Pre-Bid Conference
Lyttonsville Site – Replacement Site and Service Center

April 15, 2021

Questions/Answers

*Lyttonsville Site – Replacement Site and Service Center
Answers to all Questions Submitted by May 5, 2021*

Lyttonsville Service Center Exterior Circulation Summary

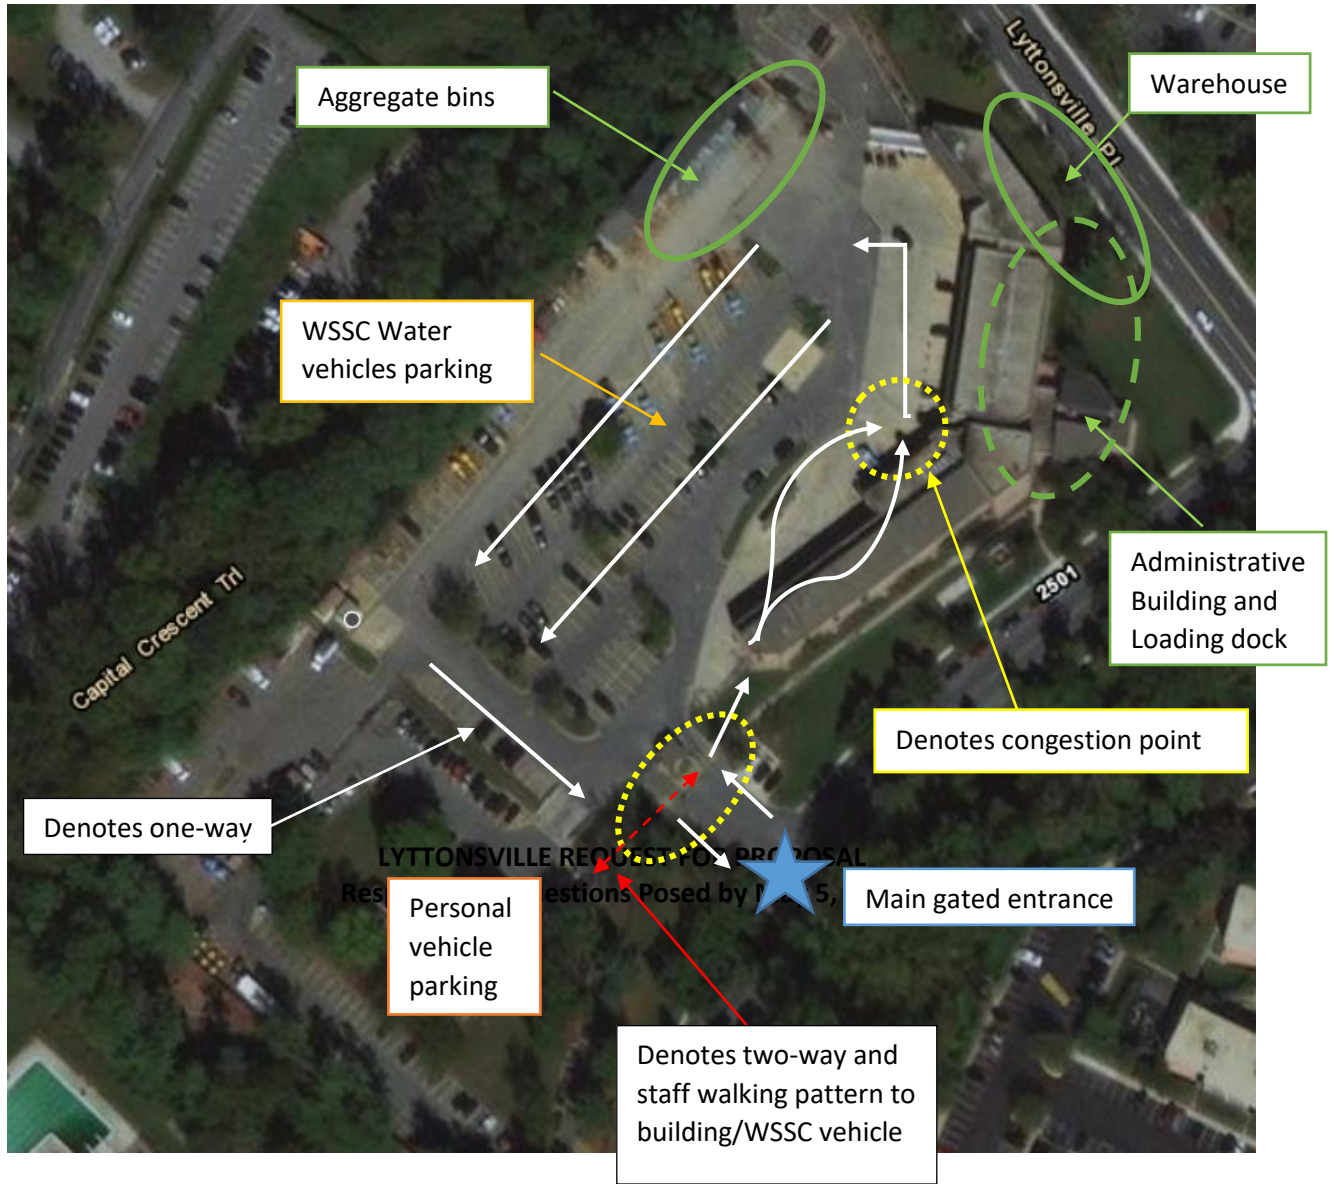
Can you provide a description of the sequence of truck movements within the depot throughout the day? What are the normal operations of the site? Do the drivers follow a routine process?

A description is attached to these notes.

The circulation pattern varies depending on the days, tasks and operational needs of personnel to include material deliveries and pick-ups to the warehouse and the aggregate storage bins located at the far side of the facility. Below is a summary of a typical workday between 6:30-9:00 AM. The hours could vary depending on the urgency of the assignment.

A typical workday involves field staff and inspectors entering the facility through the main gated entrance around 6:30 AM – 7:00 AM. This does not include administrative staff entering the facility. The staff would park their personal vehicle (POV) at the designated employee surface lot. They would walk across the main entrance, where staff are continuing to enter the depot, and across the Commission vehicle parking lot to enter the building. They would retrieve their daily tasks, equipment, and/or supplies before heading to their WSSC Water vehicle. This retrieval process could be anywhere between 30 minutes to an hour. The staff are typically deployed between 8:00-8:30 to their work location(s) where they will be stationed most of their day. Before heading to their job location, some of the staff will need to pick up a WSSC Water truck and load up their supplies and equipment at the designated loading dock or hitch their equipment to their truck before leaving the site. All traffic is typically cleared out by 9:00 AM. During the hours between 9:00-2:00 PM, there is no major congestion unless there are unscheduled deliveries to the warehouse or the storage bins. Around 2:00 PM, the field staff would return to the depot and the circulation/traffic pattern is like the morning pattern. Staff would enter the facility through the gated entrance, park their WSSC Water vehicle in the designated spot rather than head to the POV lot, enter the building, drop off their supplies/equipment, log in their daily work and walk to the POV lot. All staff is typically out of the facility between 3:00-4:00 PM.
